#2010-50
McHenry County Mental Health Board
Project Review for Planning and Zoning Commission

<u>Meeting Date:</u>	September 1, 2010
<u>Zoning Request:</u>	Final Planned Unit Development Amendment to allow an addition to the existing McHenry County Mental Health Building.
<u>Location:</u>	620 Dakota Street
<u>Acreage:</u>	0.886 acres
<u>Existing Zoning:</u>	O-PUD
<u>Surrounding Properties:</u>	North (M-L), Vacant land South (O-PUD), Office East (O-PUD), Office West (M), Office
<u>Staff Contact:</u>	Elizabeth Maxwell 815-356-3615

1 SITE PLAN
A000 1/16" = 1'-0"

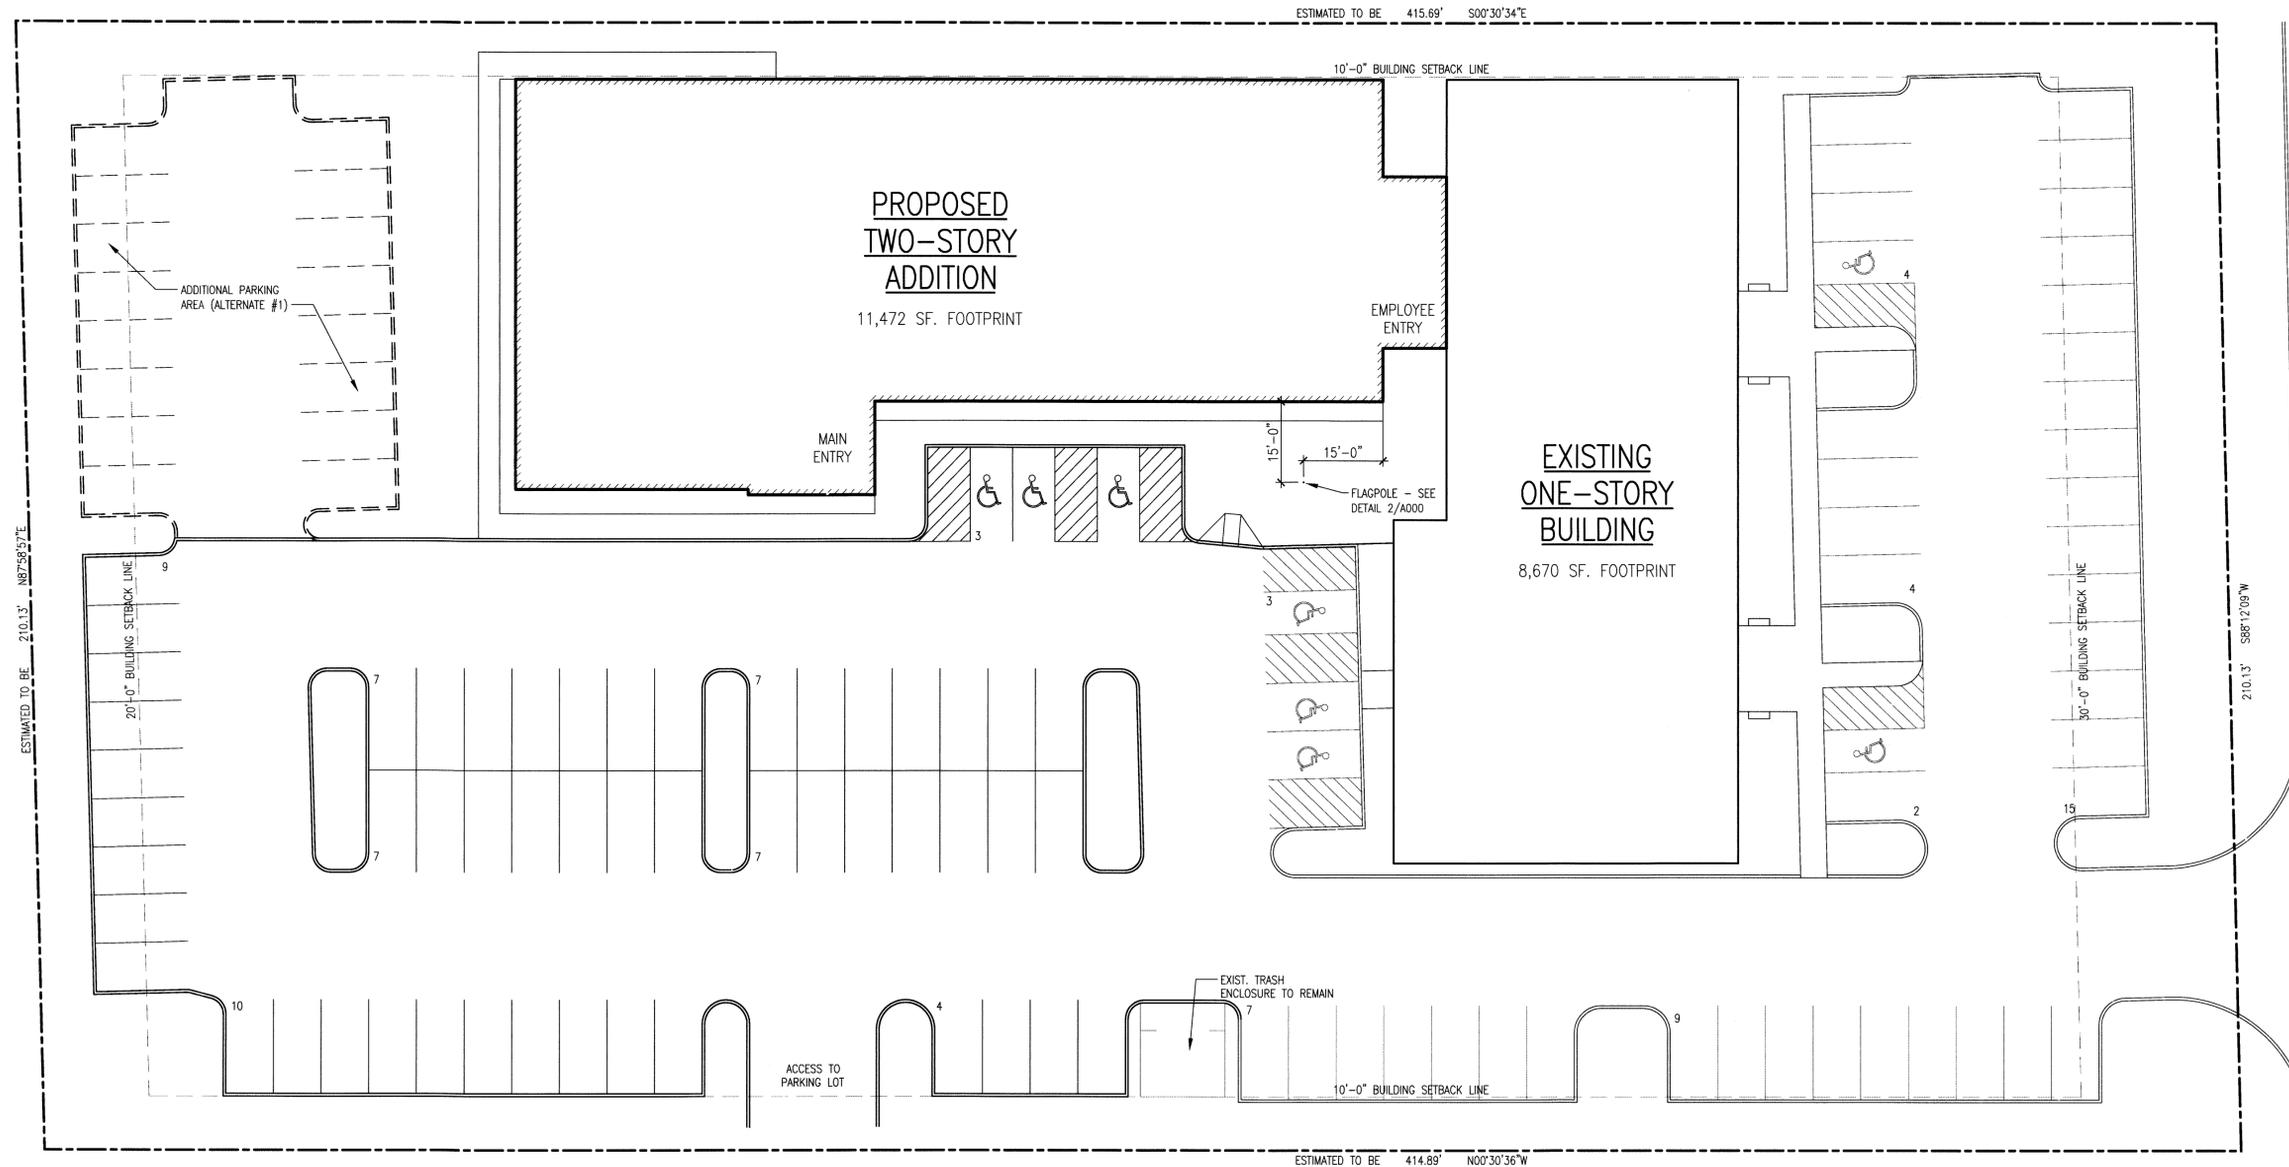
This lot was landlocked surrounded by office buildings and the County Health building. The new building is a two-story 22,560 square foot addition and would create additional office space. The new addition is located behind the existing building, which fronts on Dakota Street. The required parking for office space is 126 spaces; the site would provide 114 spaces. A portion of the parking lot, 16 spaces, is planned as an alternate and would be paved if additional parking is needed. McHenry County Health shall be responsible for providing the necessary parking on site. Staff shall monitor the parking in this area and if it is noticed that there is a parking problem the owner shall be required to provide the additional parking immediately.

EXTERIOR ELEVATIONS

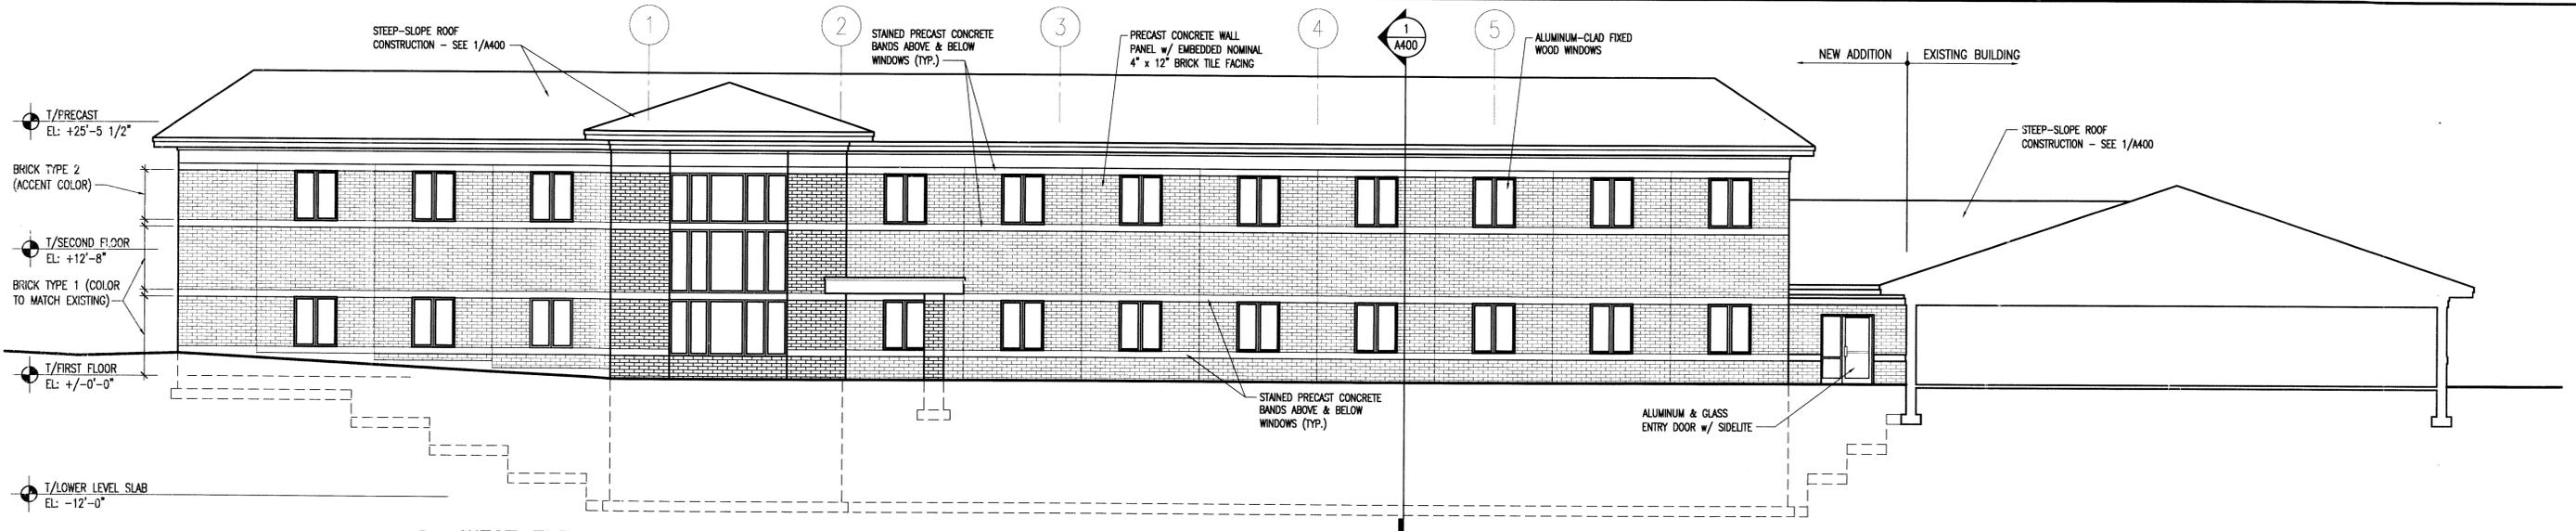
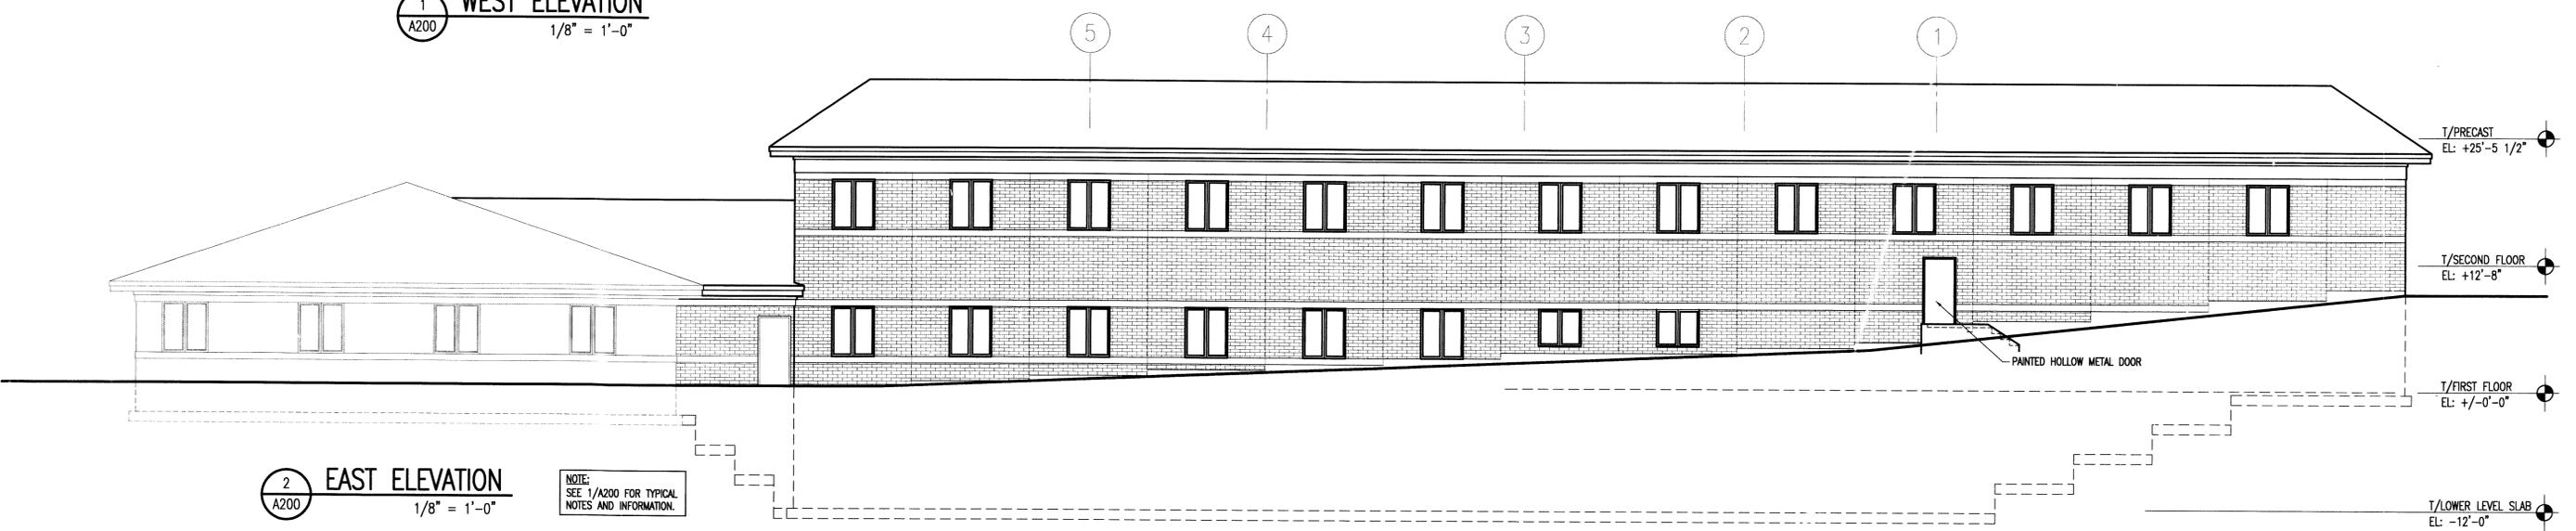
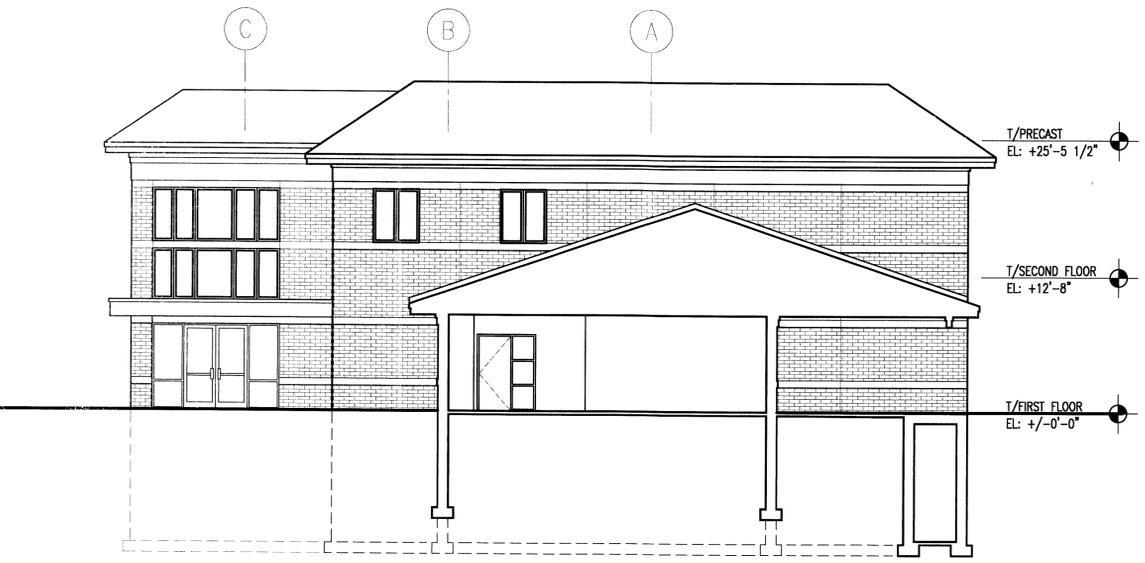
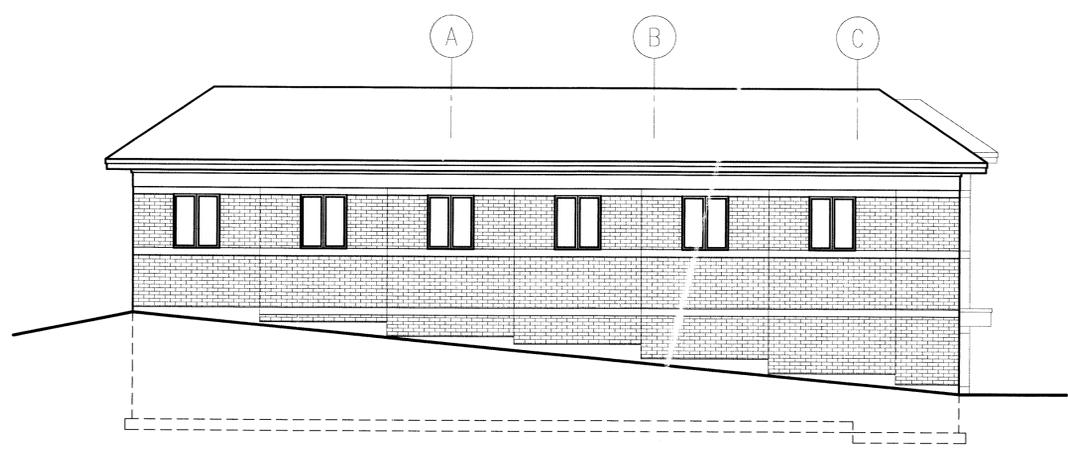
The new building would match the exterior materials, style and roof slope of the existing building. The building would be brick with concrete banding. The windows are aluminum clad wood windows to match the existing windows. Staff is suggesting that one window be added on the south elevation at the second-story corner office to match the look of the other corner office. The existing building will hide most of the new addition from Dakota Street. Any roof mounted mechanical equipment shall be painted to blend with the roof color and screened as necessary.

1 LANDSCAPE PLAN
L100 EXIST. LANDSCAPING SHOWN LIGHT
1/16" = 1'-0"

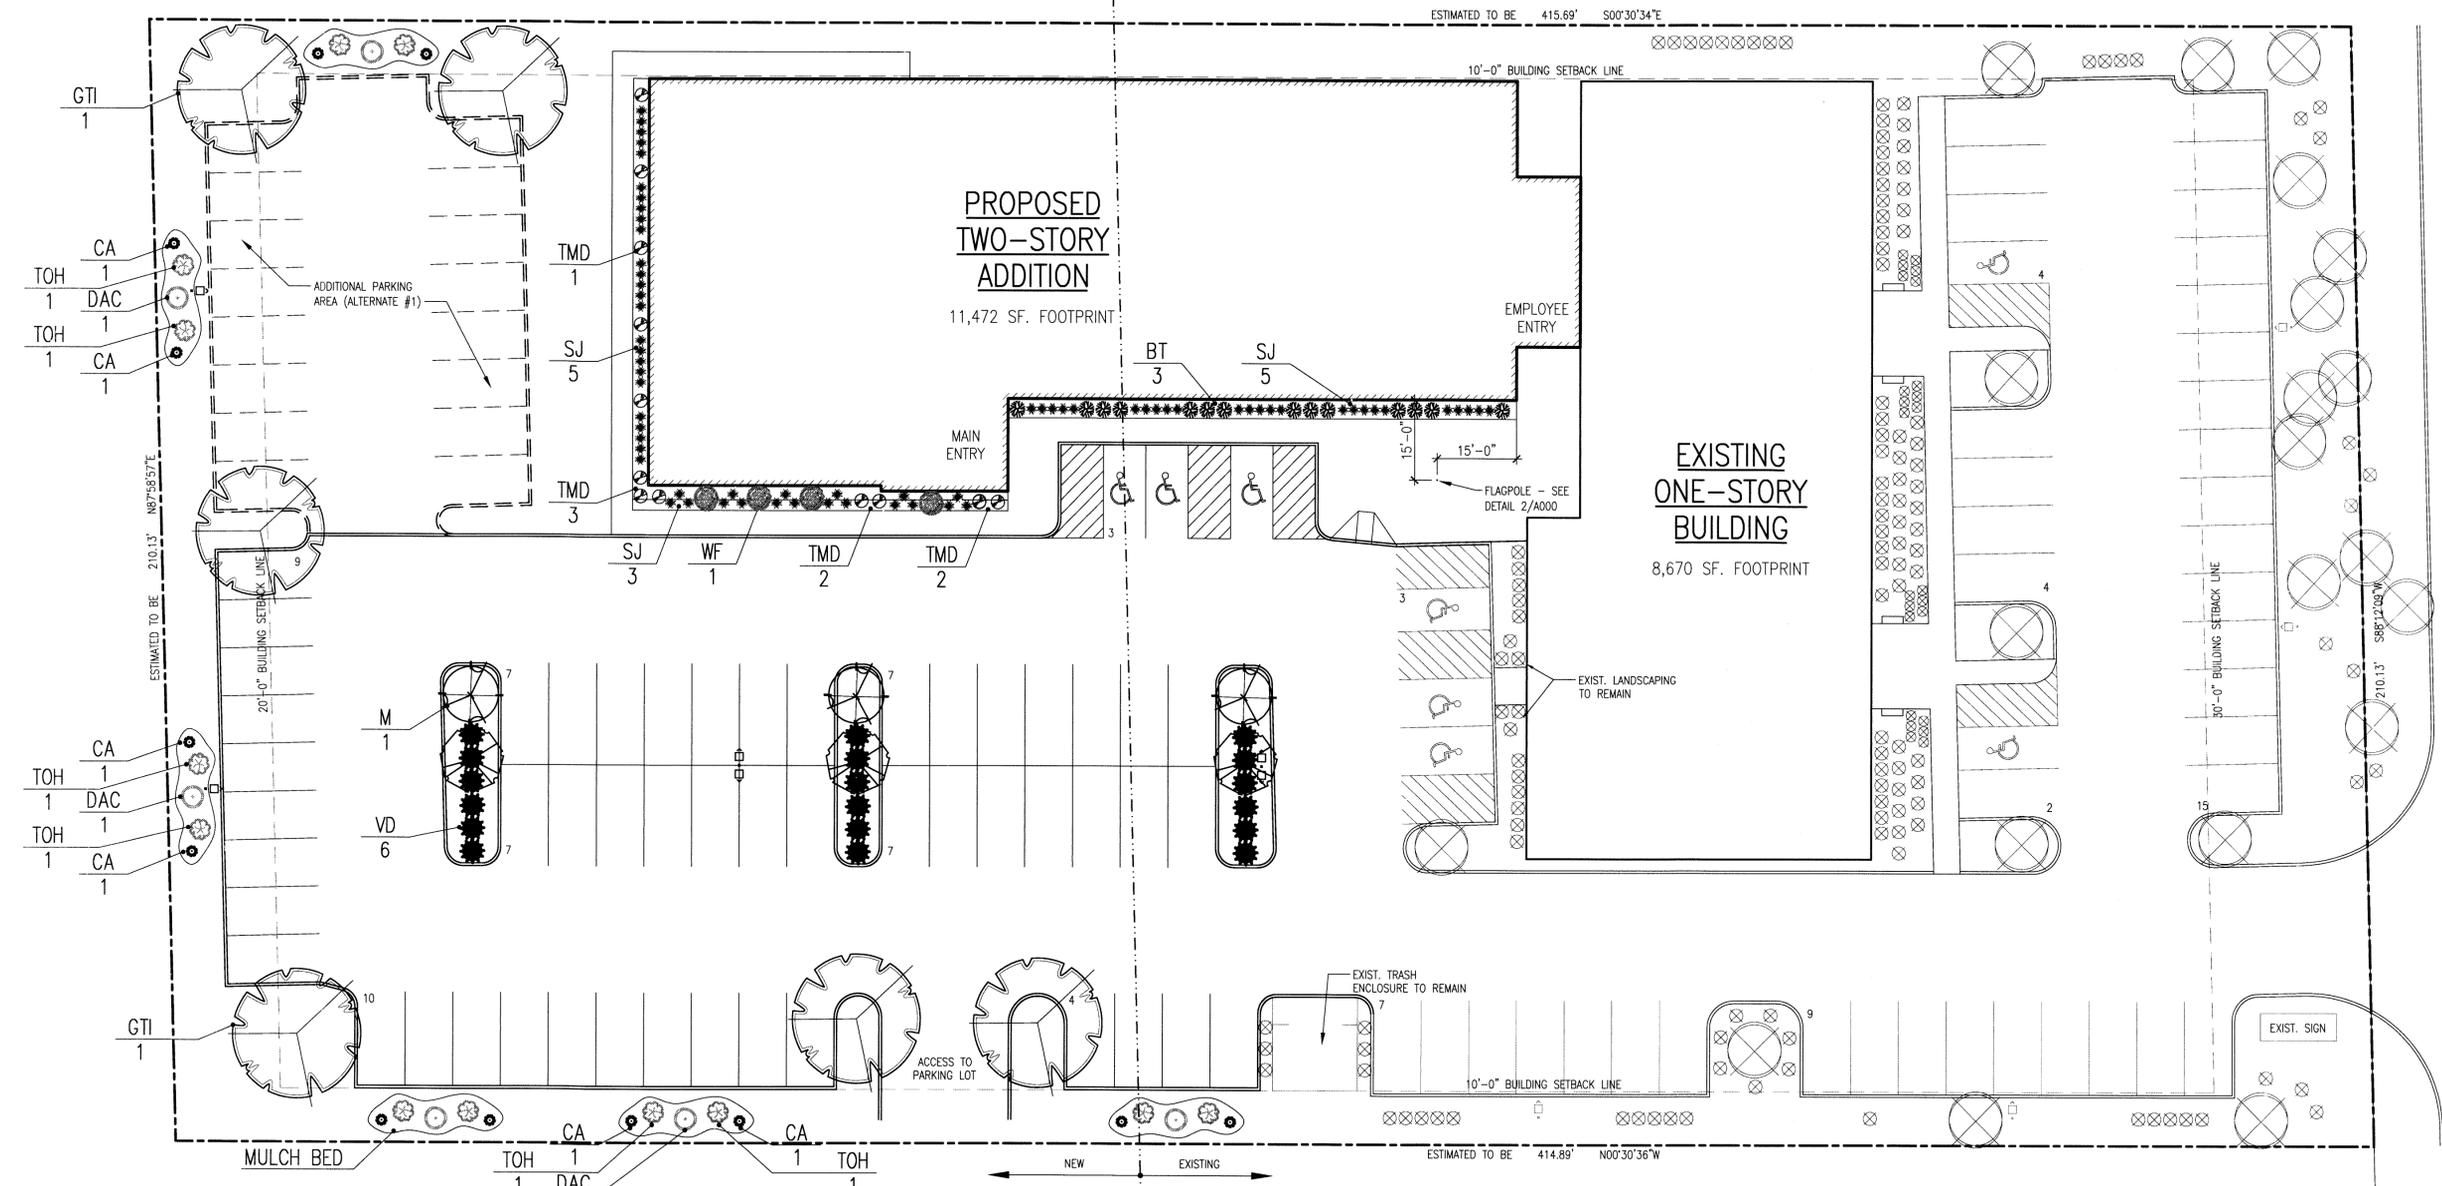
The new parking lot area will be landscaped with a variety of deciduous and evergreen shrubs. Several new Honey Locust trees and Prairiefire Crabapple trees will be planted in the parking lot islands. The new building will have foundation base landscape plantings around the west and north sides. The new landscape will complement the existing landscape.
